## MEMORANDUM

SUBJECT: RESULTS FROM CONSULTATION WITH CONTRA COSTA CAC

CONCERNING PROPOSED USE OF A WAREHOUSE FOR ENCLOSING

**FUMIGATED INTERMODALS**

Photo One: Overhead view of site and warehouse

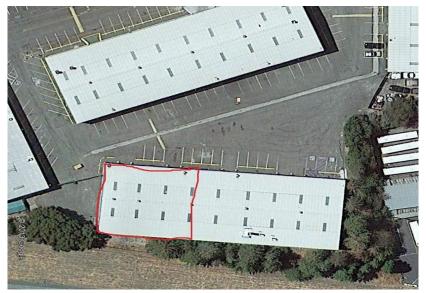
The warehouse is located in Concord, in an industrial area. It is a metal structure, with roll up doors, situated within a cluster of like-constructed buildings (Photo One). The enclosed area under consideration is approximately 80' by 40' by 20' (see red outline in Photo One).

Initially, the CAC's concern was that the structure was a shared facility, with other business and their employees who could be potentially exposed during the fumigation operation. The proposed fumigation procedure is to deliver, into the warehouse, an intermodal trailer, preloaded with commodity subject to fumigation. The trailer would be tarped, sand snaked and otherwise secured for fumigation, then methyl bromide would be introduced from outside the warehouse. However, the section of the warehouse to be used for this purpose is separated from the remaining structure by a potential shear wall, rendering it functionally isolated from the rest of the enclosed structure (Photo Two).
